Maitai Dam

2013 Comprehensive Safety Review

26 June 2014

Prepared for Nelson City Council

Figure 10: Maitai Dam – Piezometer Instrument Line 1 – P23 and B23 Upper Downstream Embankment (1986-2014)

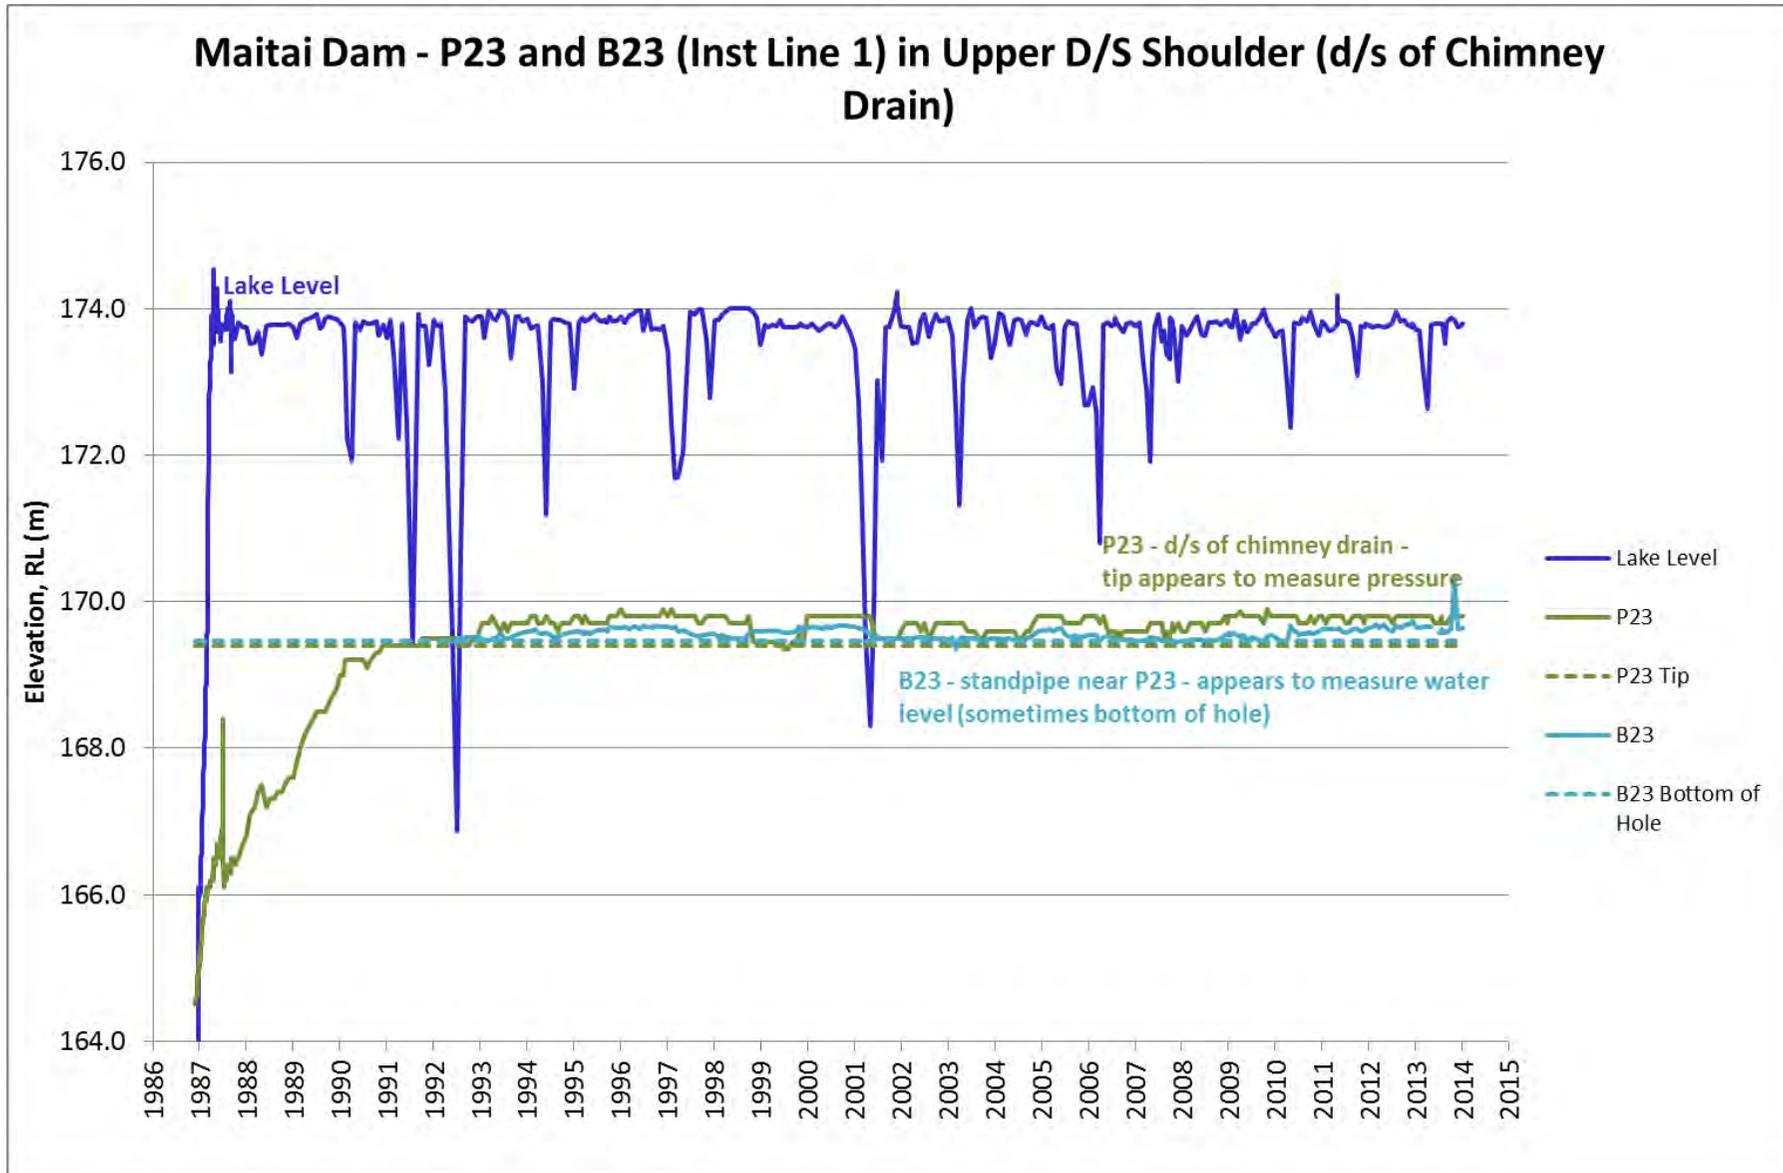
Standpipe piezometers B23 and B27 were installed around 1990, in an effort to verify data from hydraulic piezometers P23 and P27, located in the upper embankment downstream of the chimney drain (Instrument Lines 1 and 3 respectively). There are no design or as-built drawings available for B23 and B27. **(Rec-11) It is recommended that as-built location and installation details for B23 and B27 be confirmed and indicated on a drawing for the purpose of ongoing data evaluation.**

Figure 23: Areas of High and Low Stresses along Maitai Dam Foundation, Section 80

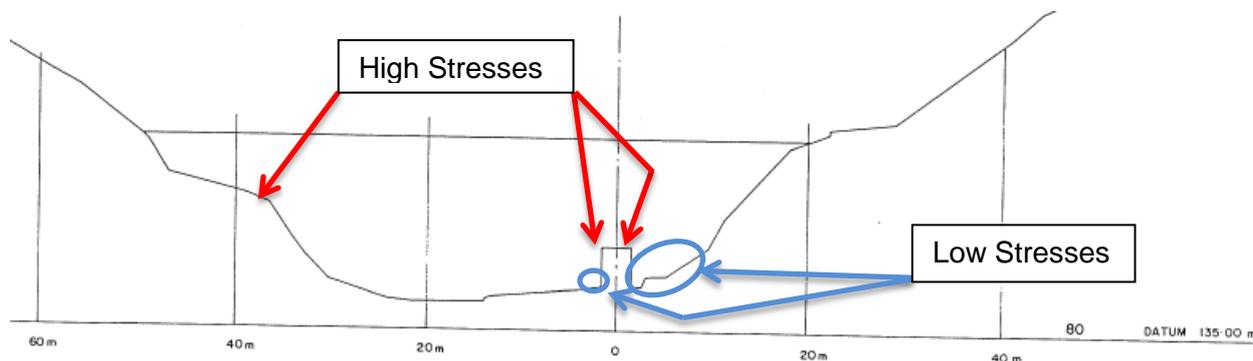
The culvert penetration and its geometry within the embankment results in areas of high and low stress concentrations for differential settlement and cracking to likely occur. The culvert geometry from upstream to downstream is shown on the foundation profile drawings. The sharp corners of the culvert create areas of high stress concentrations while the corners at the culvert base result in areas of low stresses. The potential for differential settlement and transverse cracking also depends on compaction obtained along the culvert. Construction documents state fill material along the culvert was well compacted using hand equipment. The upstream 14 culvert bays, however, include plywood panels placed on the sides. The long-term implications of the plywood on the contact of fill against the culvert needs to be considered when evaluating ongoing performance of the dam for cracking and internal erosion.

DRAWING No. 6516-215 AB
 DATE DEC 1987

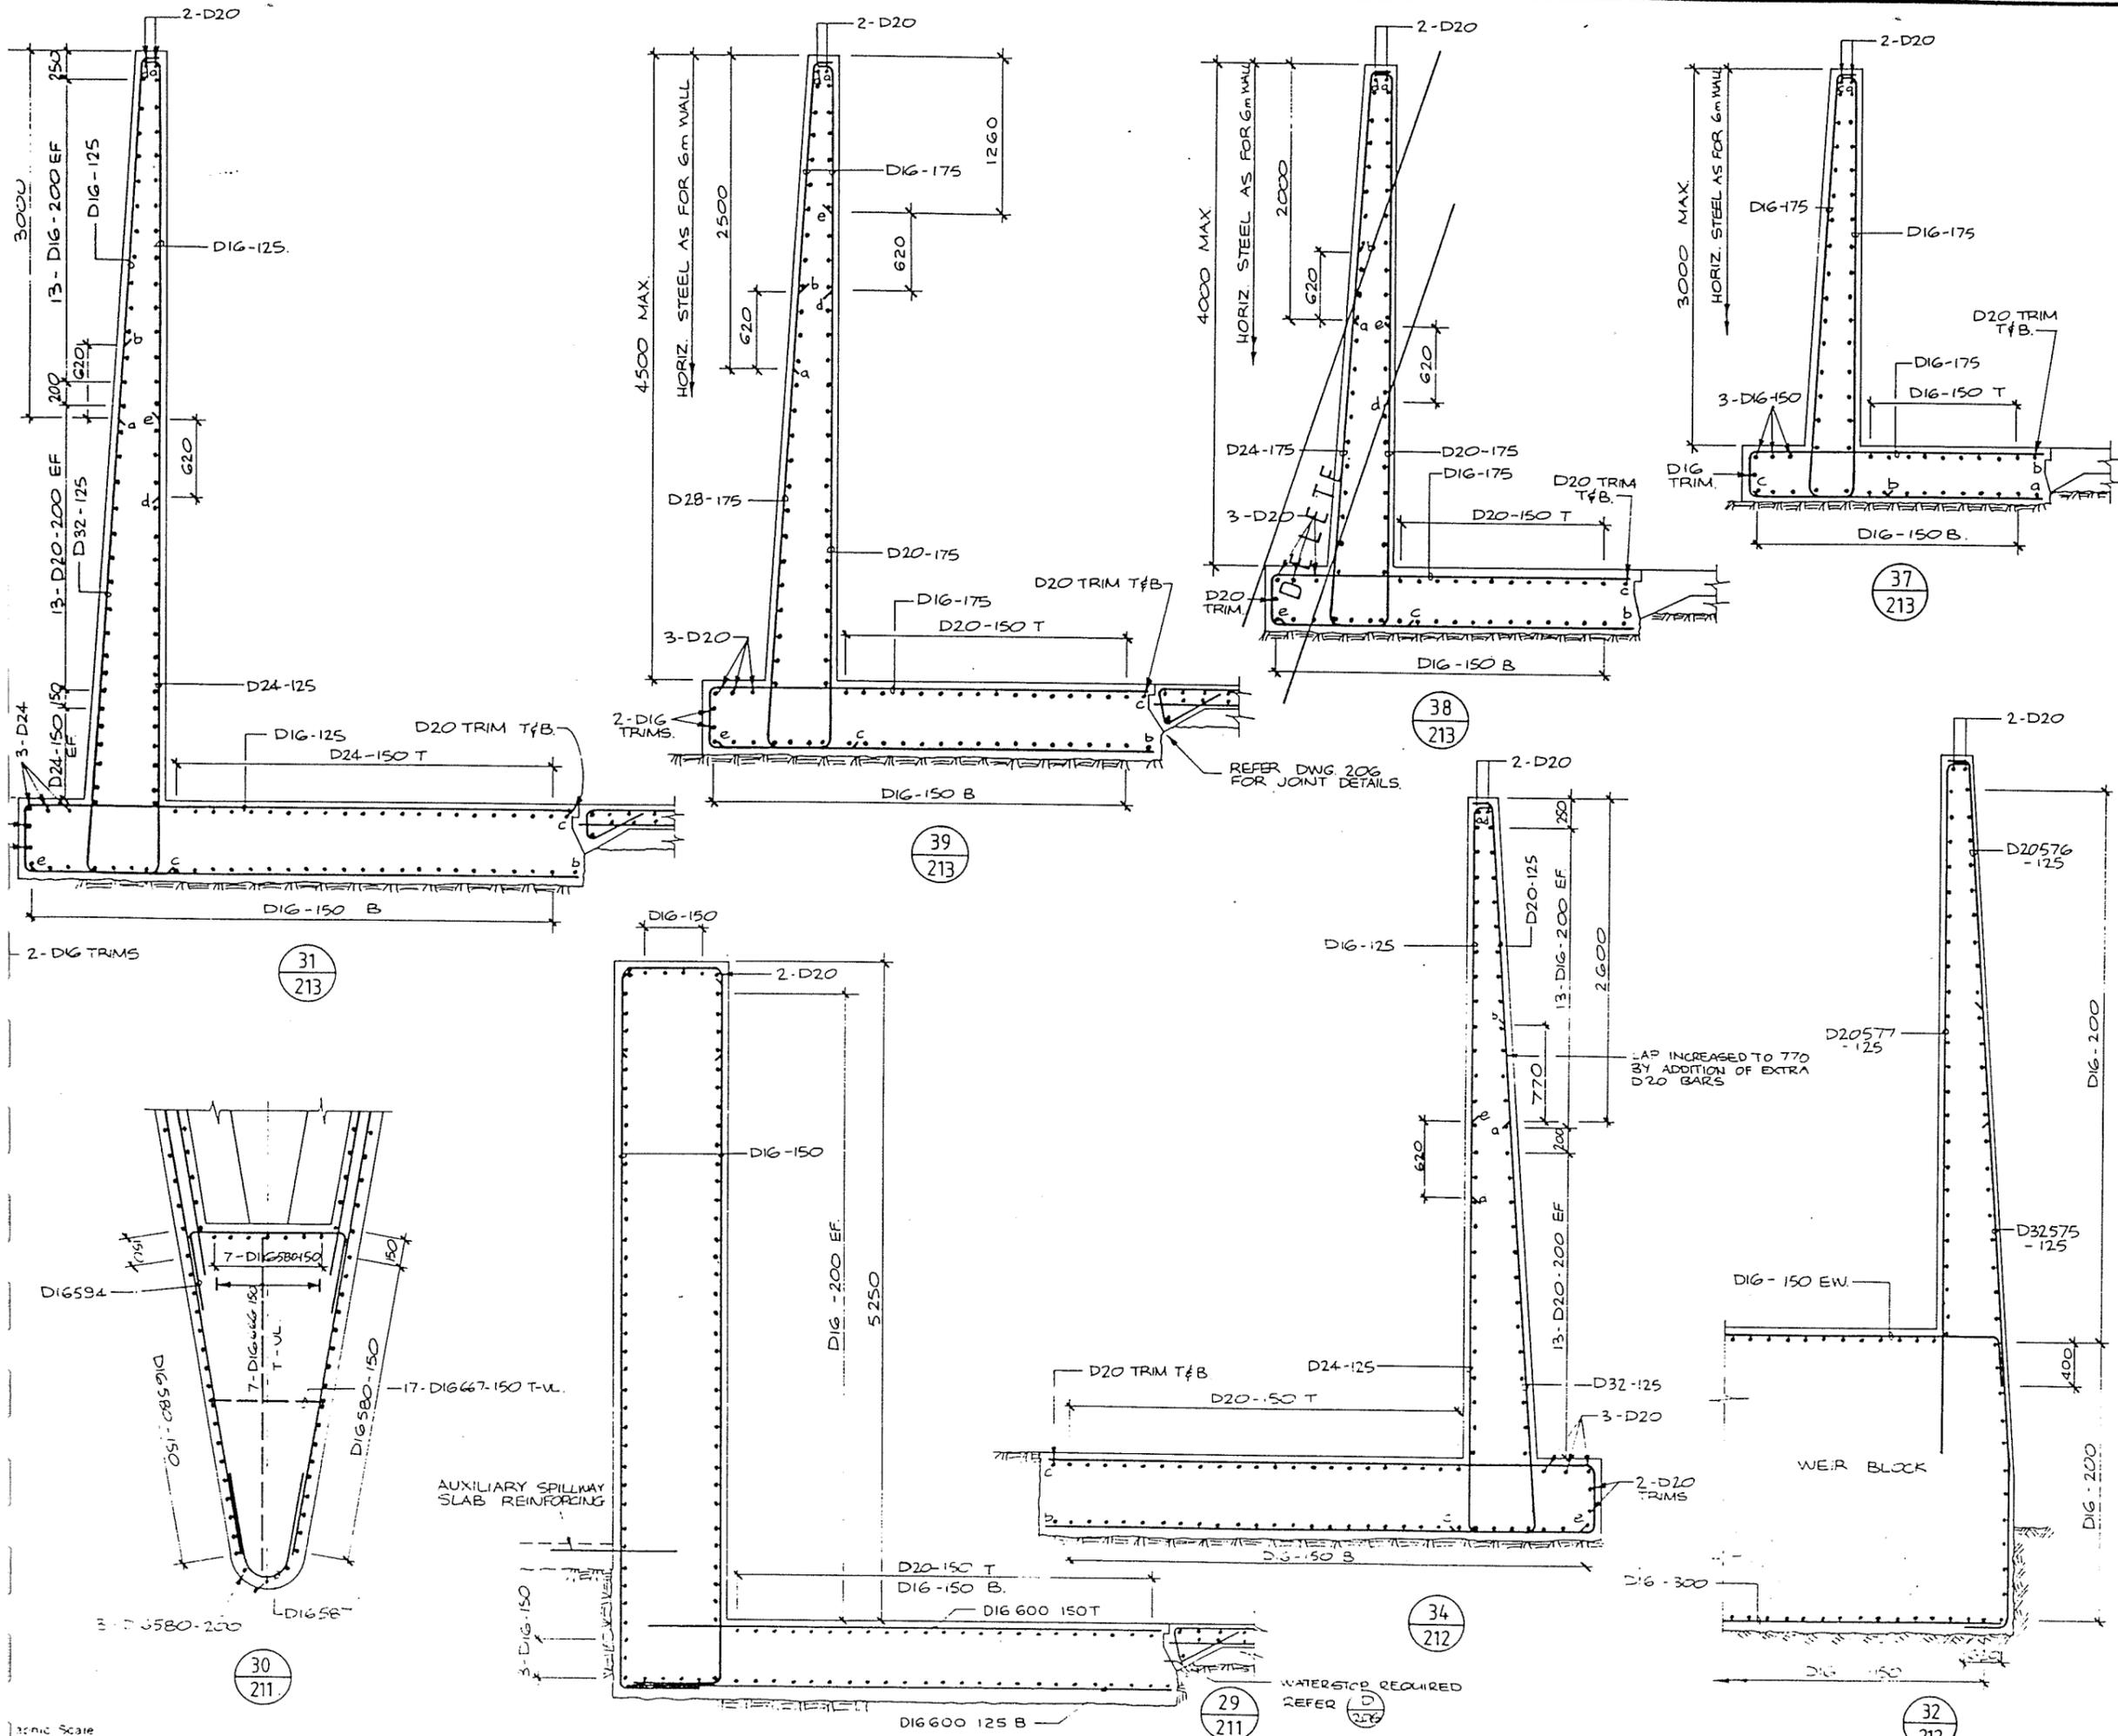
It is pertinent to mention that transverse reinforcement for spillway wall base as shown in as-built Drawing 6516-215 AB appears to be inconsistent with general industry practice. The wall sections indicate less reinforcement in the transverse direction (across flow) compared to the longitudinal direction (along flow). The forces acting on the wall require main reinforcement in the transverse direction and only nominal reinforcement in the longitudinal direction. This could be a drafting mistake, but design (Tonkin & Taylor, 1986) and construction (Tonkin & Taylor, 1987) reports do not provide clarity on it. The calculations were based on the reinforcement shown in the drawing.

Photo 21: Seepage Emerging from L.H.S. Abutment Drain

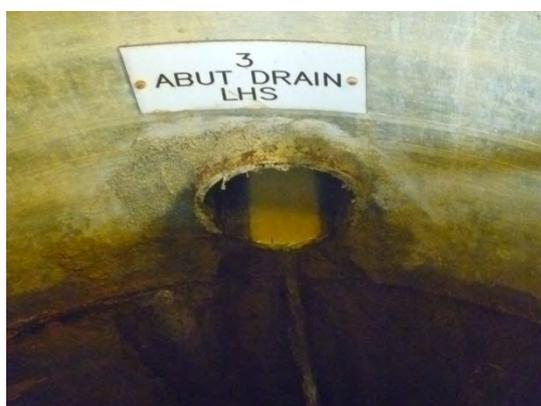
| Item | Comments/Action Required |
|--|--|
| <p>3. Monitoring Facilities Inspect: - Embankment seepage: Left and Right Abutments Contact Drains</p> | <p>Observed low clear seepage flow from left abutments contact drain. Gas detector alarm sounded in manhole, repeat previous recommendation for H&S to change method of seepage flow monitoring (Photo 21).</p> |

Photo 26: New Leakage at Right Side of Downstream Culvert Area

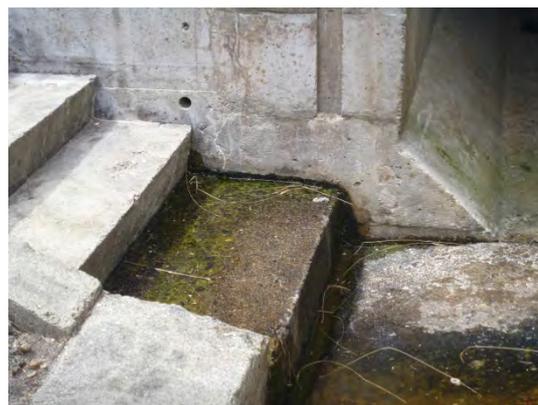
| Item | Comments/Action Required |
|--|--|
| <p>Left and right culvert exits area drains</p> | <p>No seepage observed from either the right or left drains (Photo 25). Seepage was observed emerging from corner of first step on right and retaining wall; this is a new seepage. Leakage may be due to blockage of drain or damage at pipe joint (Drawing 6516-15 AB) (Photos 25-26). (Rec-08) It is recommended that seepage emerging adjacent to the culvert be monitored with documentation on its development.</p> |

No seepage was observed from the R.H.S. culvert exit area. Over the review period, flows were typically at 0.73l/s with one high flow of 0.870l/s on 2 October 2010. Over 2013 minimal flows were recorded. During the CSR site inspection, leakage was however observed emerging from the right side at the corner of the first step and the south retaining wall (refer Appendix C). This is near the pipe joint of the R.H.S culvert drain to the retaining wall 110mm diameter drainage pipe, as shown on Drawing 6516-15 AB. The low leakage observed in 2013 (average of 0.031l/s) and observed leakage may indicate blockage or damage to the drain outlet, possibly during construction of the secondary water supply line. **(Rec-15) It is recommended the right exit area drain be checked for damage or blockage in regards to the new seepage observed (ref: Rec-08).**
